EXHIBIT 1 - STAFF REPORT

DATE: May 12, 2020
TO: Landscape Review Committee Members
FROM: Jamie Fleckenstein, Associate Planner
SUBJECT: Agenda Item 4A – Landscape Plan Review Application (L 13-19)

An application for a landscape plan review (L 31-19) for landscaping for the development of a new multiple-family residential apartment building at 1025 NE 1st Street to be reviewed by the Landscape Review Committee.

Figure 4: Proposed Landscape Plan**Figure 5: Proposed Plant Schedule****Discussion:**

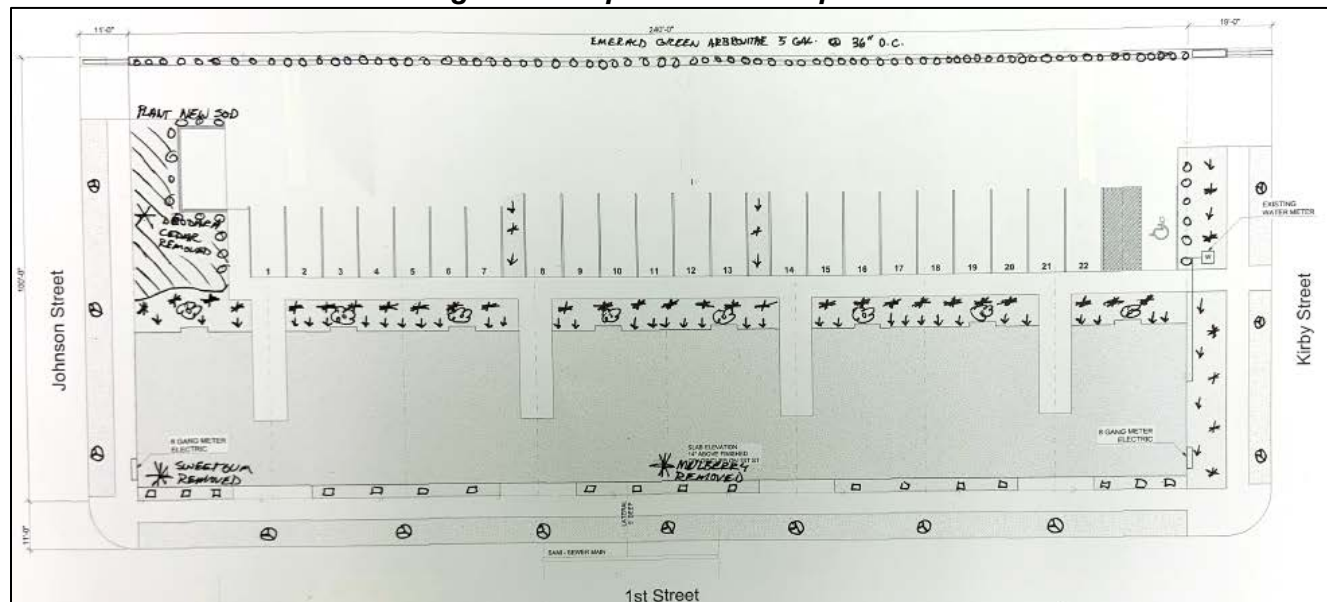
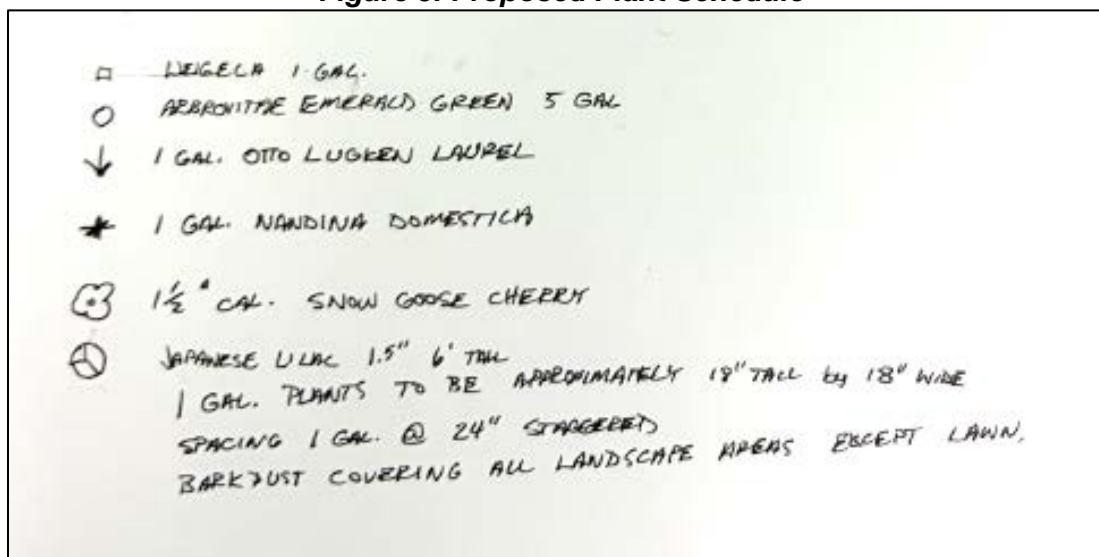
Kirby St trees appear to exceed maximum mature height of 25' for trees planted under power and communication lines.

McMinnville Water & Light cannot approve the landscape plans as drawn. The sidewalk on Kirby Street is not drawn correctly. The existing water meter drawn on the drawing is not there anymore. The drawing does not show the new water meter and fire line valve with their backflow devices and FDC, nor the existing fire hydrant.

East of the parking area is a landscape area with a proposed Emerald Green Arborvitae hedge to screen parking from Kirby Street right-of-way. The clear vision area standard for multi-family residential driveways described in MMC Section 17.54.080(B)(2) requires a clear vision triangle with legs measuring 10 feet minimum. No planting exceeding three (3) feet in height can be within the clear vision area. Therefore, a condition of approval is included to require that no planting exceeding three (3) feet in height shall be within the clear vision areas of the multi-family residential driveway.

CONDITION FOR FINDING: That no planting exceeding three (3) feet in height shall be within the clear vision areas of the multi-family residential driveway.

CONDITION FOR FINDING: That *Syringa reticulata* 'Ivory Silk' (Ivory Silk Japanese Tree Lilac) is approved for use as a street tree adjacent to the subject site.

Figure 4: Proposed Landscape Plan**Figure 5: Proposed Plant Schedule****Summary of Criteria & Issues**

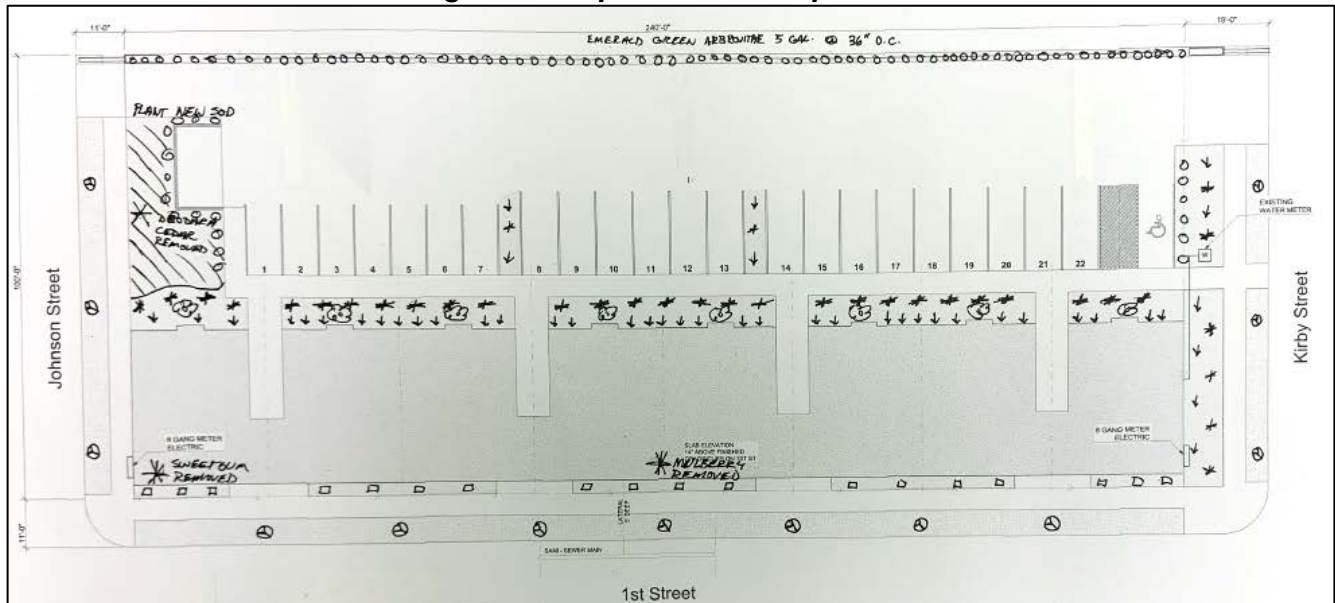
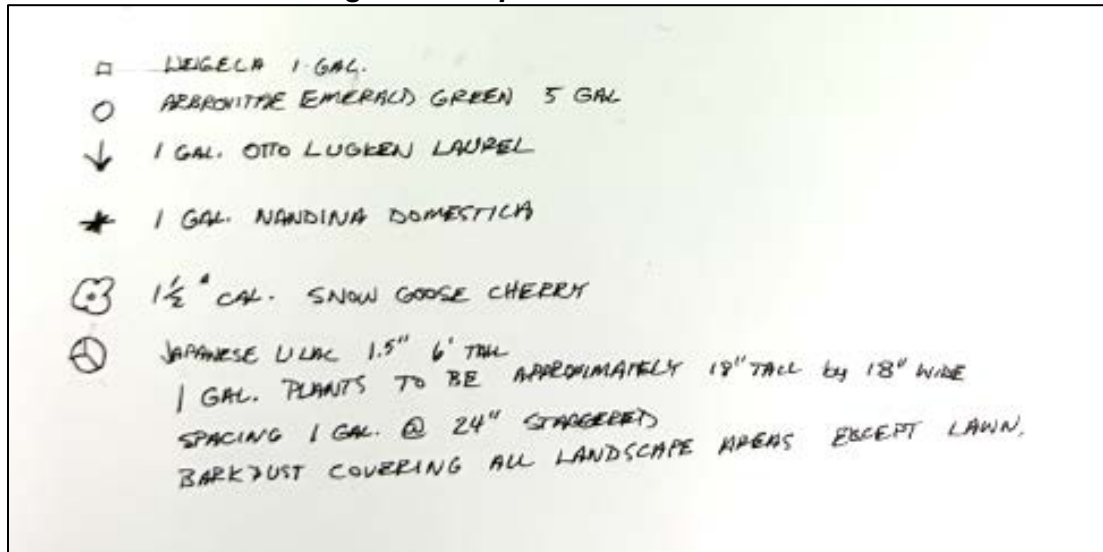
1. The submitted landscaping plan shows Japanese lilac as a street tree. Public Works has no experience with this tree, and it does not appear on the approved street tree list. However, it is also consistent with the existing cherry trees along that corridor. Our only comment would be to verify that these trees will be able to be kept pruned 8' above the sidewalk and 13' above roadway as they mature.
2. The remainder of the plantings are outside of the public right of way, and are thus are not within our purview.
3. Public Works would recommend approval of this proposal.

2. That no planting exceeding three (3) feet in height shall be within the clear vision areas of the multi-family residential driveway.
3. That *Syringa reticulata* 'Ivory Silk' (Ivory Silk Japanese Tree Lilac) is approved for use as a street tree adjacent to the subject site.

- c. Twenty (20) feet of street light standards or street intersections.
7. That the applicant shall maintain proper clearances around the existing and future water and electrical services that will be located on the site. Landscaping shall not be placed within four (4) feet of fire hydrants, within four (4) feet of water valves, within four (4) feet of vaults, within three (3) feet of the back or side of a transformer, or within one (1) foot of water meters. Minor adjustments in plant placement from the locations shown on the approved landscape plan are allowed if relocation is necessary to meet minimum clearances.
